**REQUEST FOR CHANGE TO TECHNICAL SPECIFICATIONS  
OSCILLATION POWER RANGE MONITOR (OPRM)  
HOPE CREEK GENERATING STATION  
FACILITY OPERATING LICENSE NPF-57  
DOCKET NO. 50-354**

**HOPE CREEK GENERATING STATION  
FACILITY OPERATING LICENSE NPF-57  
DOCKET NO. 50-354  
REVISIONS TO THE TECHNICAL SPECIFICATIONS (TS)**

**TECHNICAL SPECIFICATION PAGES WITH PROPOSED CHANGES**

| <u>Technical Specification</u> | <u>Page</u>          |
|--------------------------------|----------------------|
| Figure 3.4.1.1.1               | 3/4 4-3              |

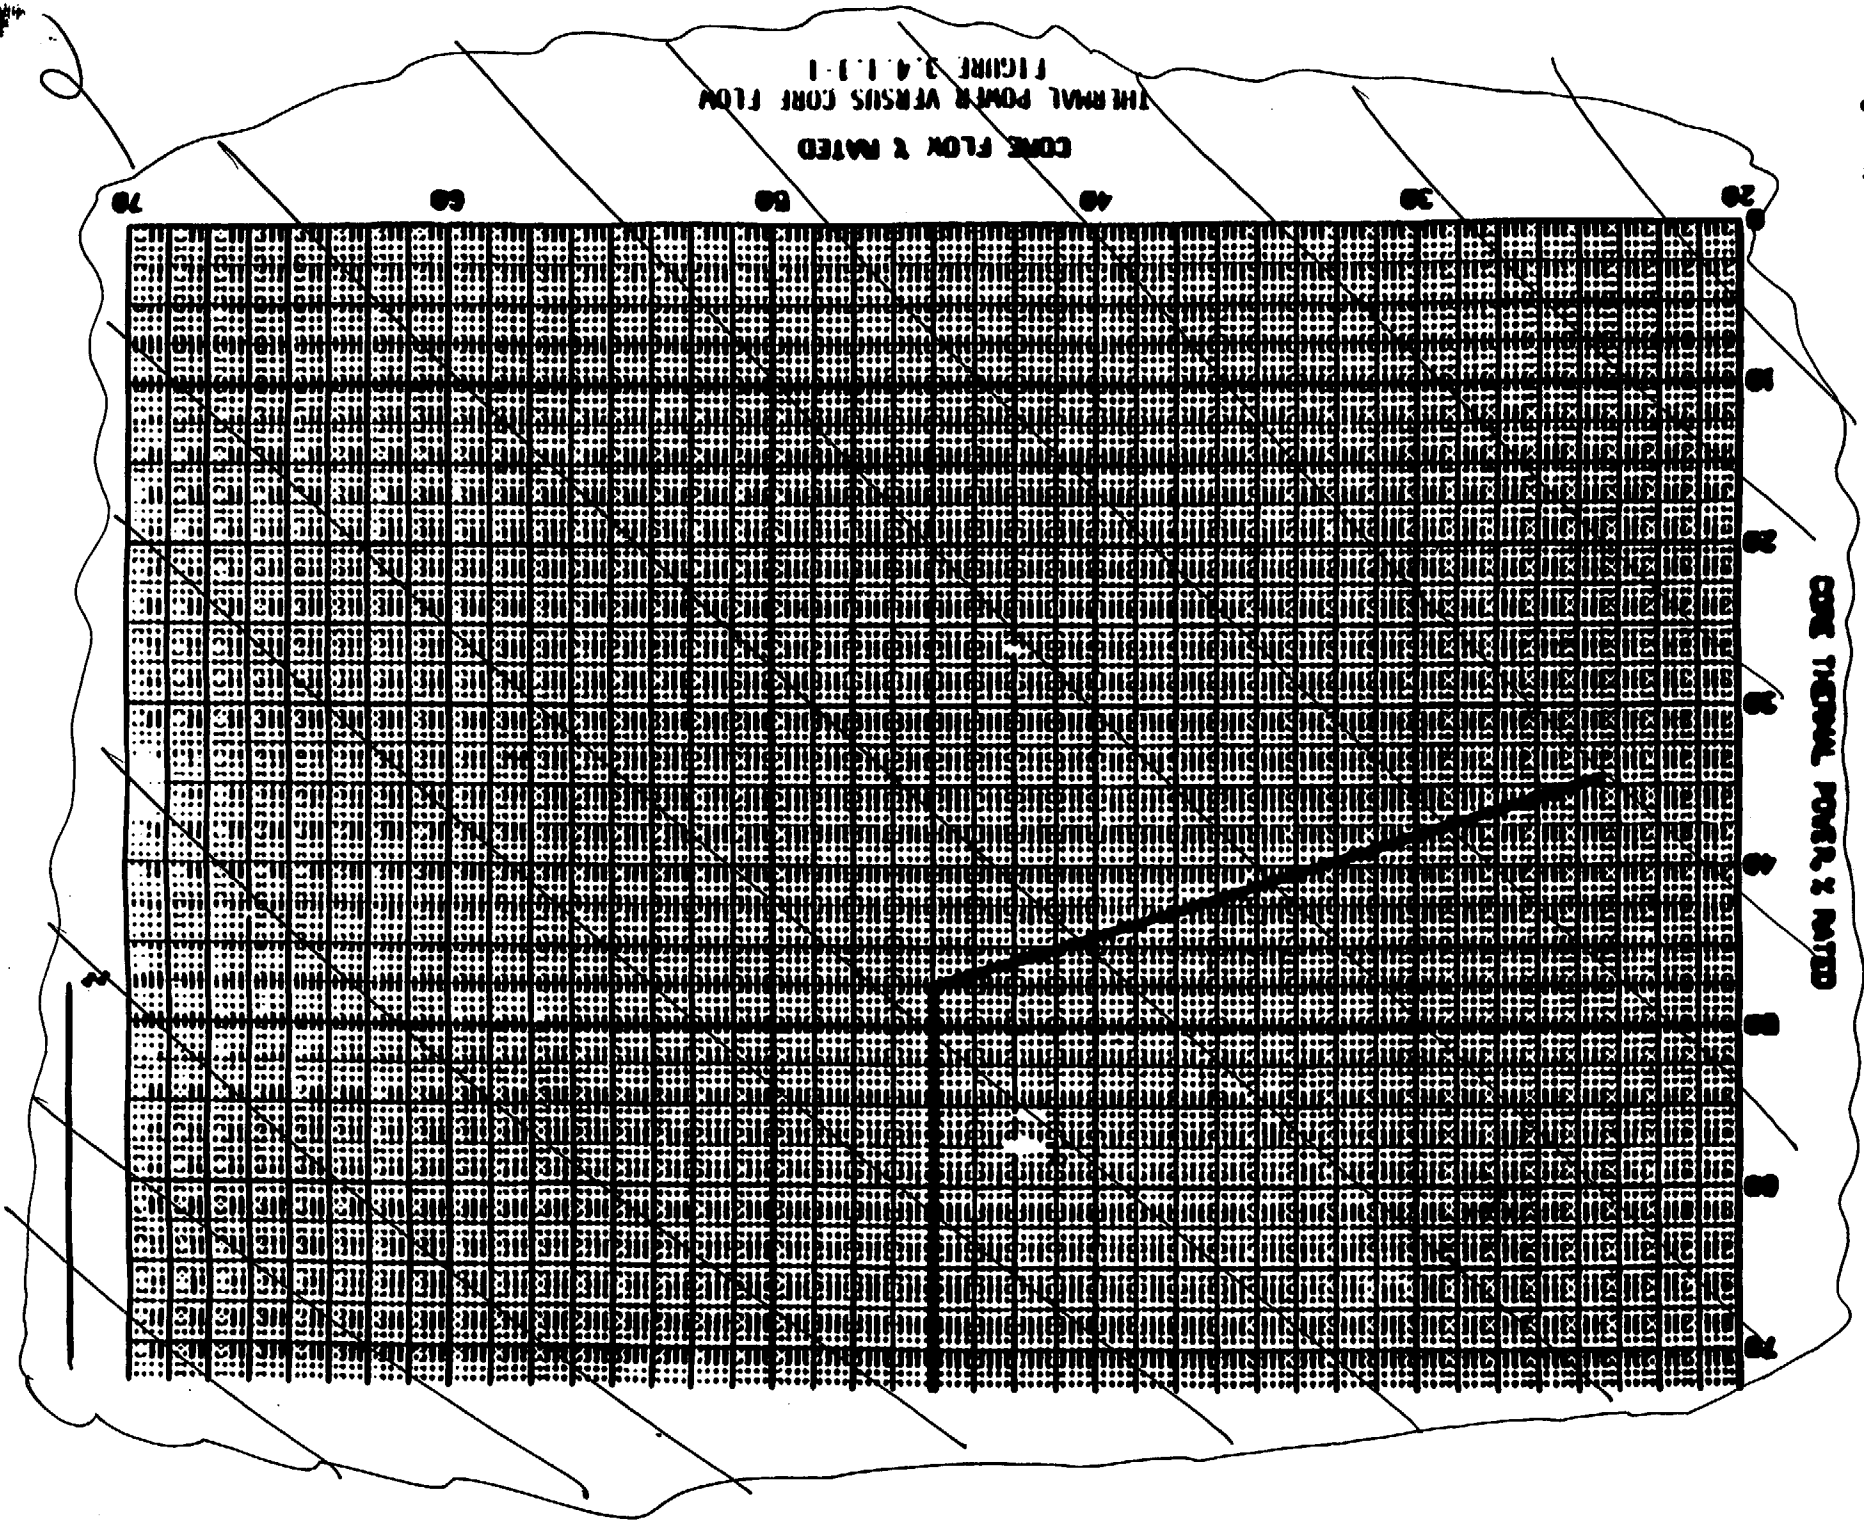
The proposed change: adds TS 3.3.10, Oscillation Power Range Monitor Instrumentation; revises TS 3.4.1, Recirculation System to eliminate restrictions upon operating in those regions of the power to flow map most susceptible to thermal hydraulic (T-H) instability; and revises TS 6.9.1.9, Core Operating Limits Report (COLR) to include the analytical methods used to determine the OPRM amplitude setpoint operating limits specified in the COLR.

The proposed change specifies limiting conditions for operations, required actions and surveillance requirements of the OPRM system and allows operation in regions of the power to flow map currently restricted by the requirements of Interim Corrective Actions (ICAs) and certain limiting conditions of operation of Technical Specifications (TS) 3.4.1. The OPRM system can automatically detect and suppress conditions necessary for thermal-hydraulic (T-H) instability. A T-H instability event has the potential to challenge the Minimum Critical Power Ratio (MCPR) safety limit. The restrictions of the ICAs and TS 3.4.1 were imposed to ensure adequate capability to detect and suppress conditions consistent with the onset of T-H oscillations that may develop into a T-H instability event. With the installation of the OPRM System, these restrictions are no longer required.
